TOWN OF NEWBURGH PLANNING BOARD TECHNICAL REVIEW COMMENTS

PROJECT NAME: GAS LAND PETROLEUM

REVIEW DATE: 15 JULY 2022 MEETING DATE: 21 JULY 2022

Re: Town of Newburgh Planning Board Project # PB 09-09

Drawing Name: \\cash.lab\Z\Projects\82000—82099\82018.00 Gas Land Petroleum Plank Road\DWG\05—PLAN_C160_82018—00_UTIL.dwg Xref's Attached: XSURV_BASE_82018_VETERE PLS; XLAYOUT_82018; XTB—82018_24x36H; XENG_82018 Date Printed: Jul 11, 2022, 4:11pm

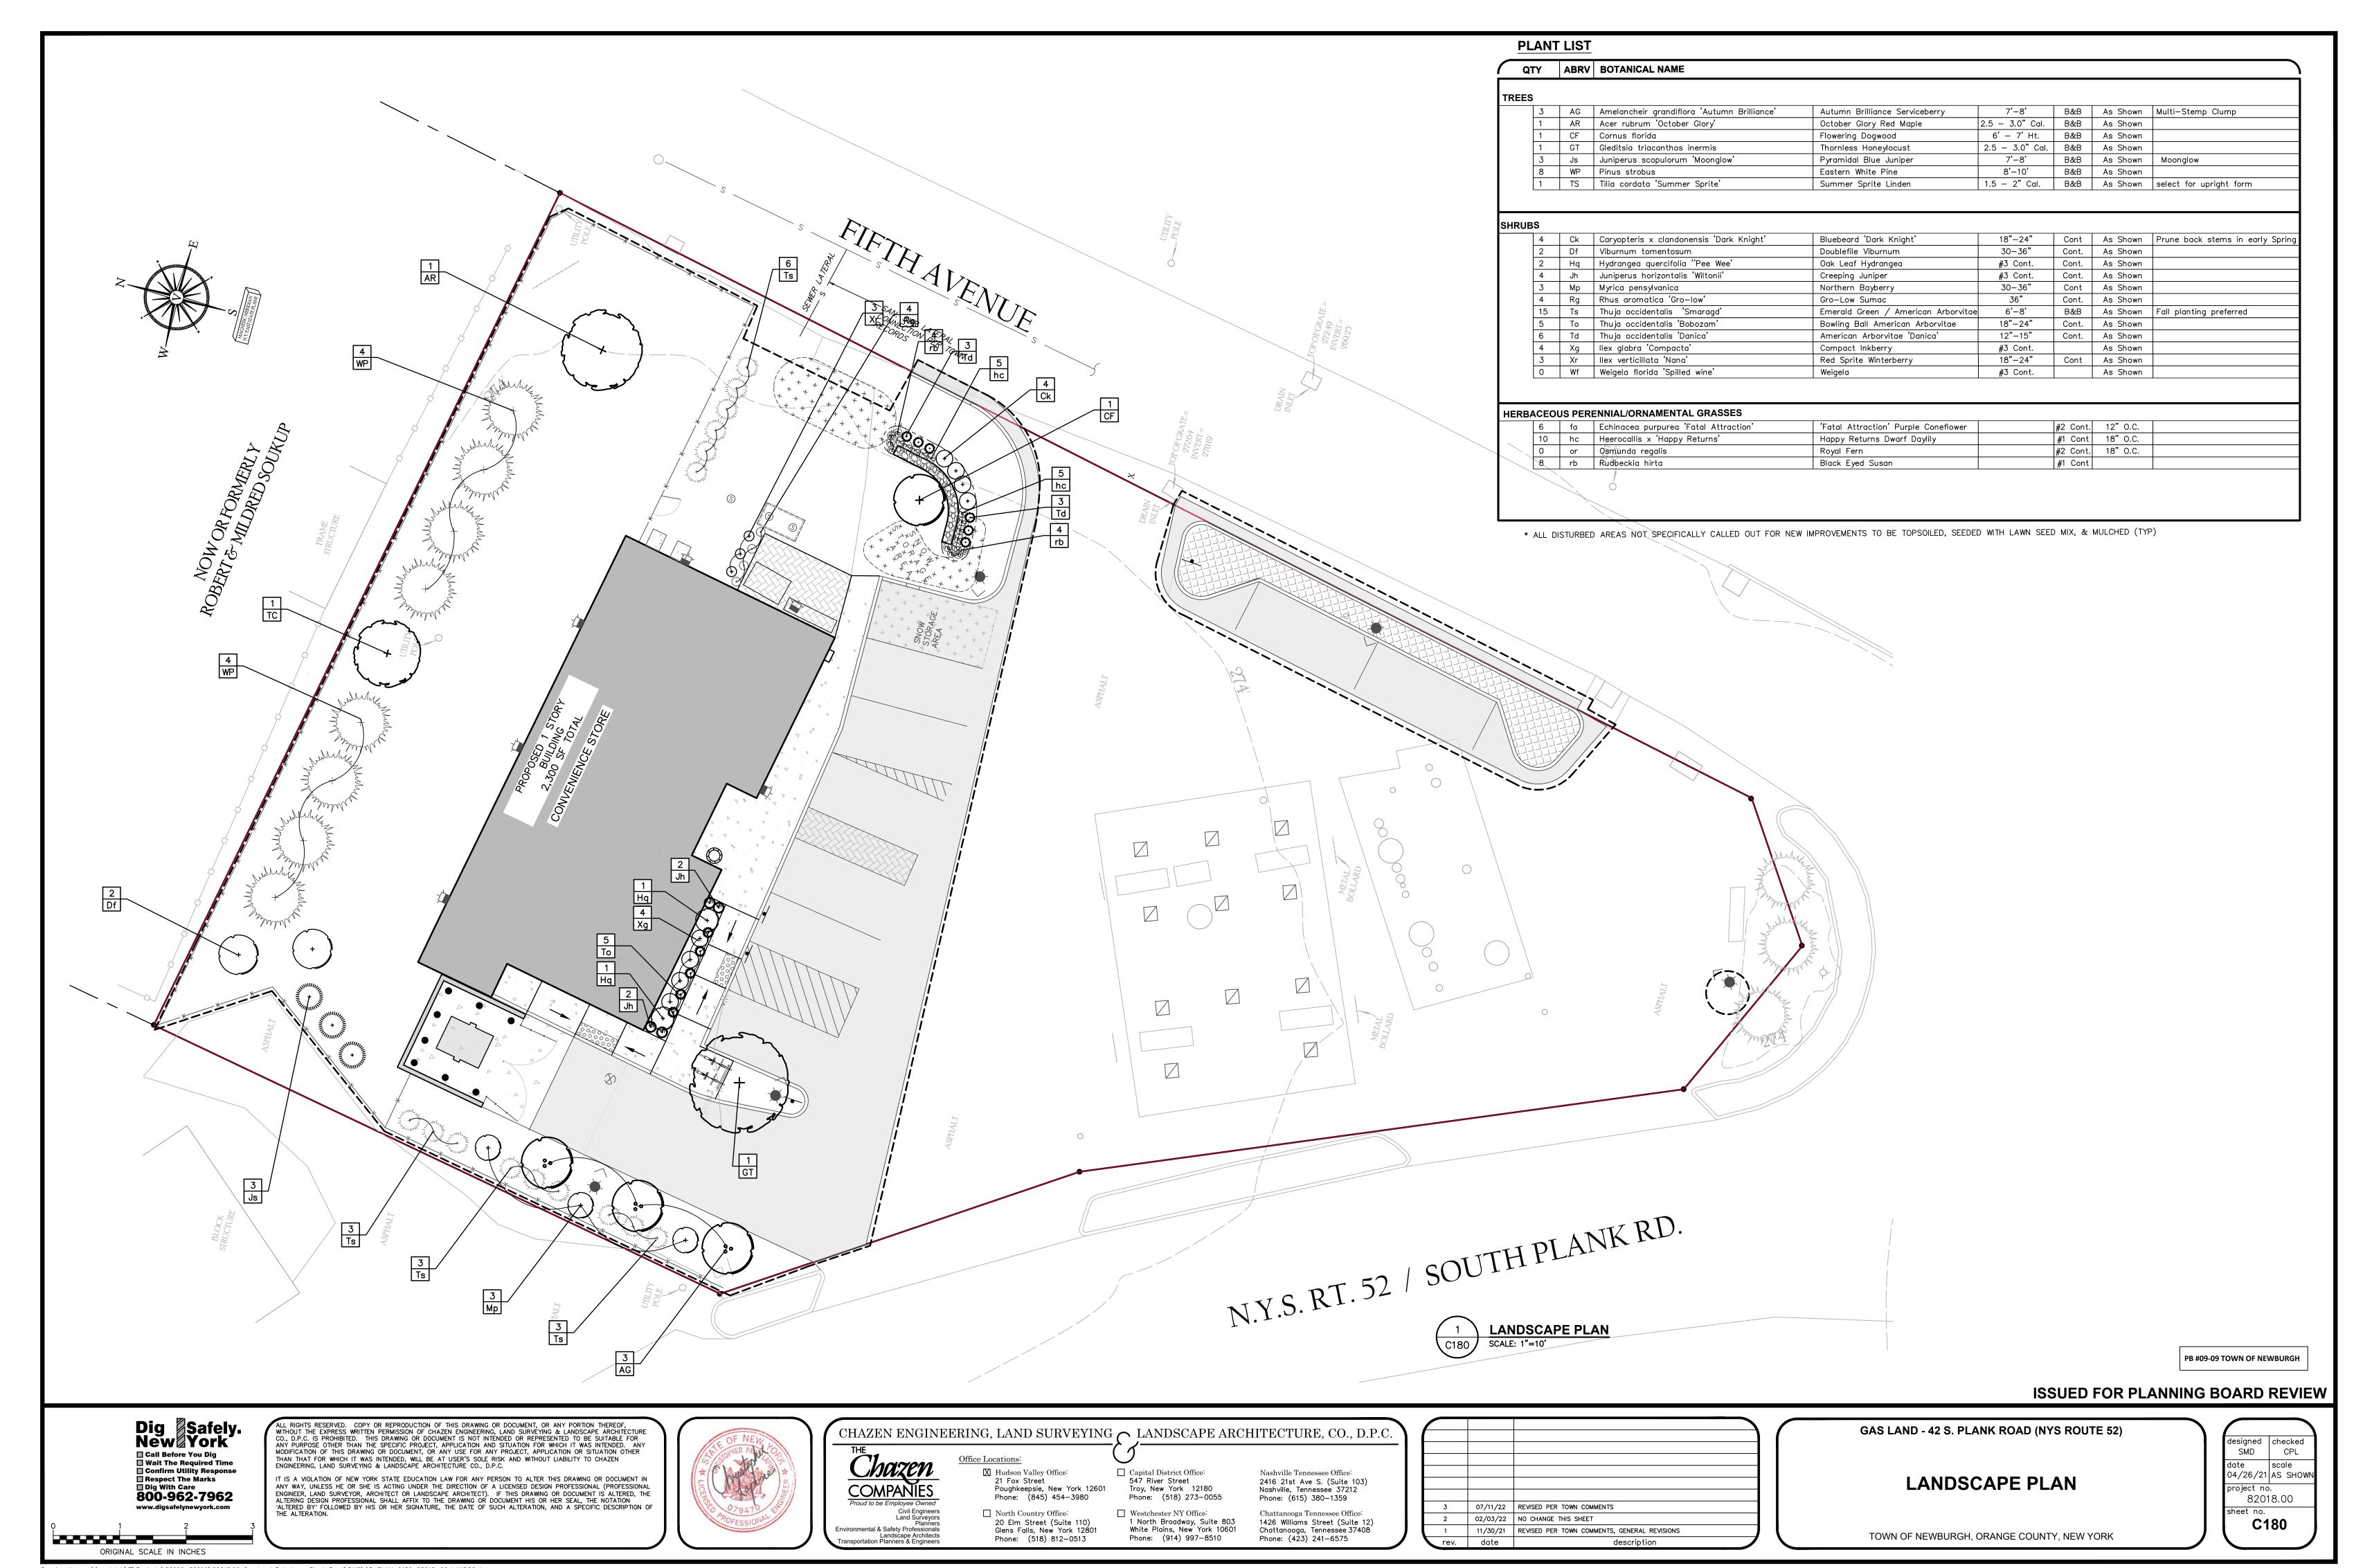
10. Show location of existing curb stop for proposed water line.

Response: Approximate location of the existing curb stop is shown on Sheet C160 per mark-out.
